DEVELOPMENT HEARING OFFICER

[PR-2019-002411](#)

SD-224-00126 – FINAL PLAT

PROJECT NAME: ISAACSON & ARFMAN, INC. | JUSTIN THOR SIMENSON agent for D.R HORTON INC. | XAVIER GARCIA requests the aforementioned action(s) for all or a portion of: TRACT FD3 UNIT 3, ASPIRE SUBDIVISION zoned R-1A, located at COLOBEL AVE between MORRISSEY ST and DUERSON TRAIL containing approximately 18.0824 acre(s). (N-08)

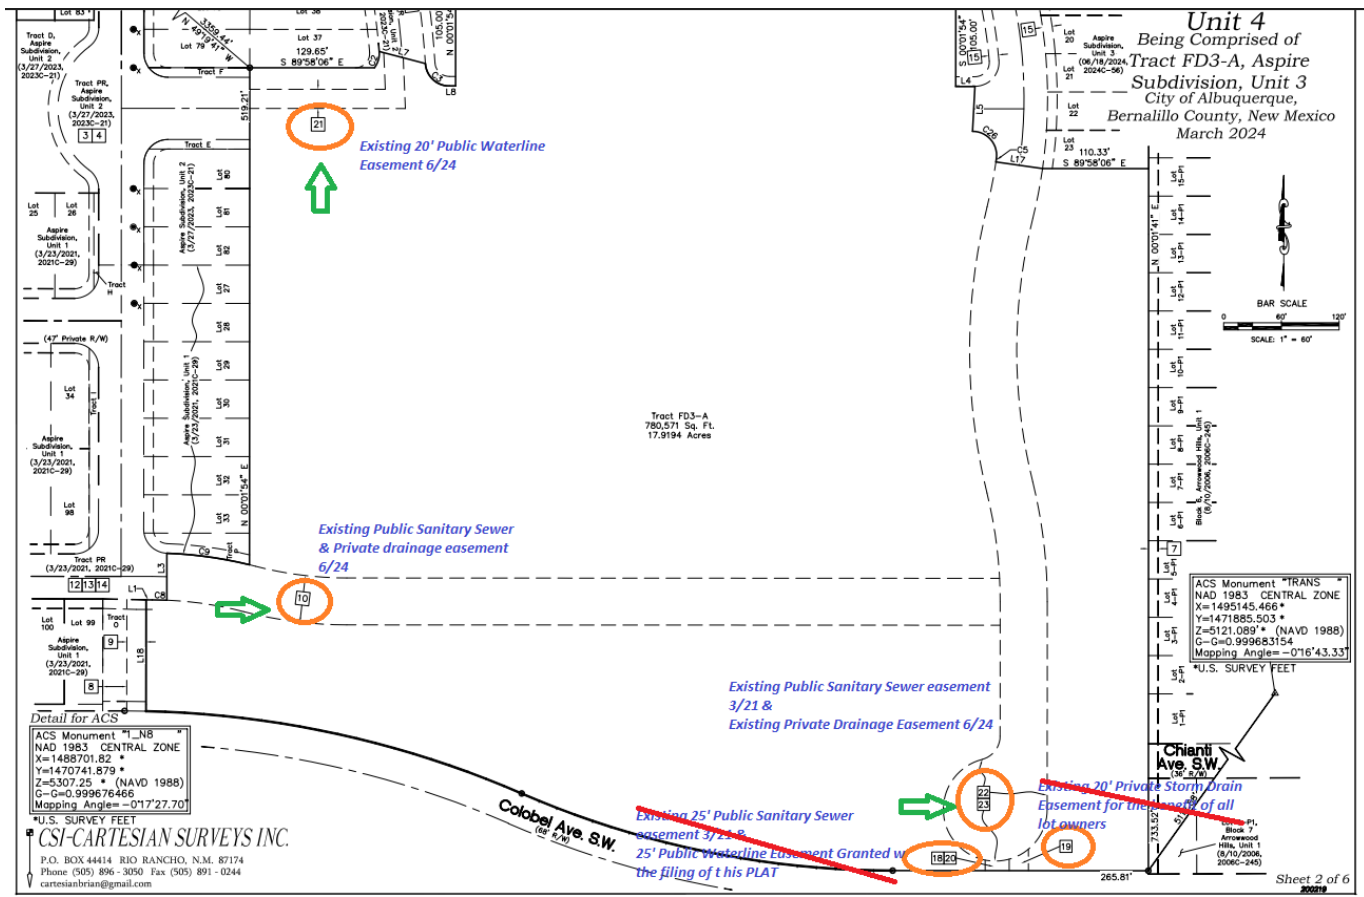
- These requests include the vacation of an existing public sanitary sewer and private drainage easement recorded on June 18th, 2024, the vacation of a 20-foot public waterline easement recorded on June 18th, 2024 the vacation of an existing public sanitary sewer easement recorded on March 23rd, 2021, and the vacation of a private drainage easement recorded on June 18th, 2024 (see Plat sheet above).

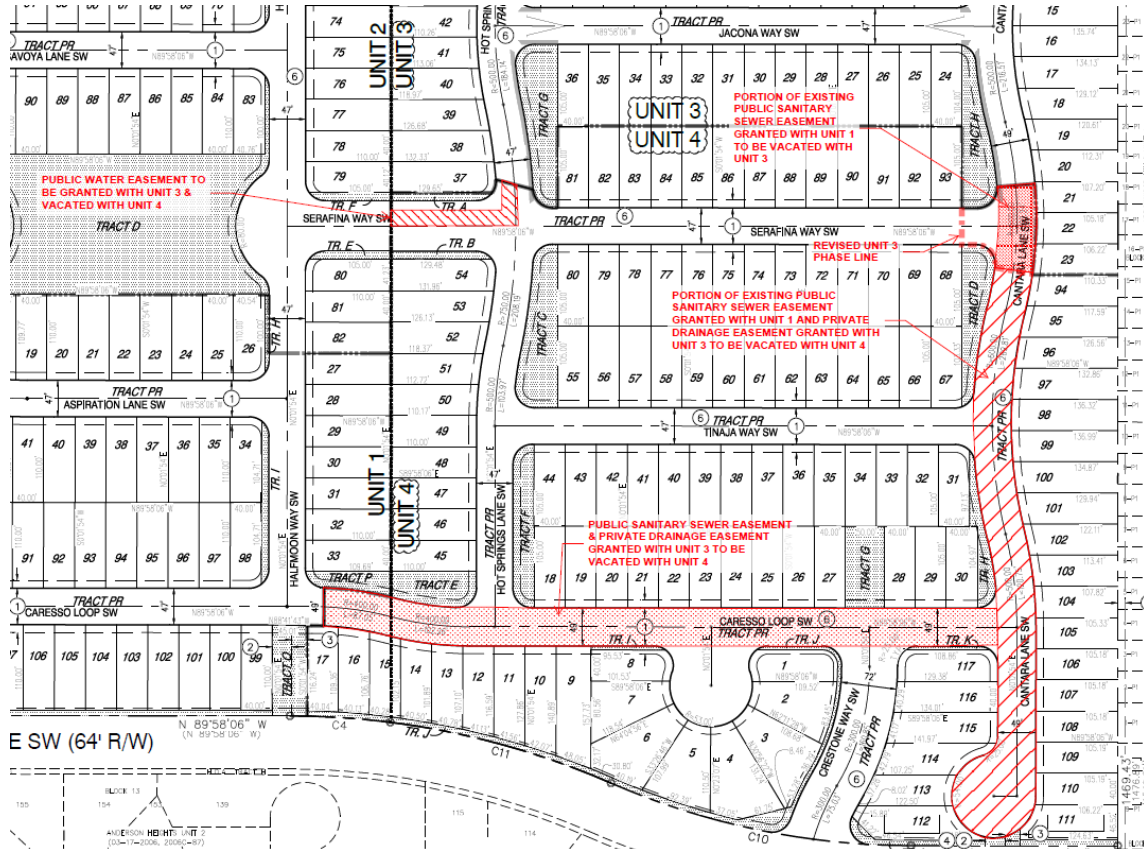
Please confirm if the vacation requests depicted on the Final Plat for Aspire Unit 4 match up with the labels/depictions for the future vacations on the amended Preliminary Plat for PR-2019-002411 / SD-2024-00088 as depicted below:

- Confirm that this request is not introducing any changes to the amended Preliminary Plat for PR-2019-002411 / SD-2024-00088.
- The Project and Application numbers must be added to the Plat.
- The date of the DHO approval shall be recorded on the Plat.
- After DHO approval and final sign off, a recorded copy of the plat must be sent to Jay Rodenbeck at jrodenbeck@cabq.gov and Angela Gomez at agomez@cabq.gov.
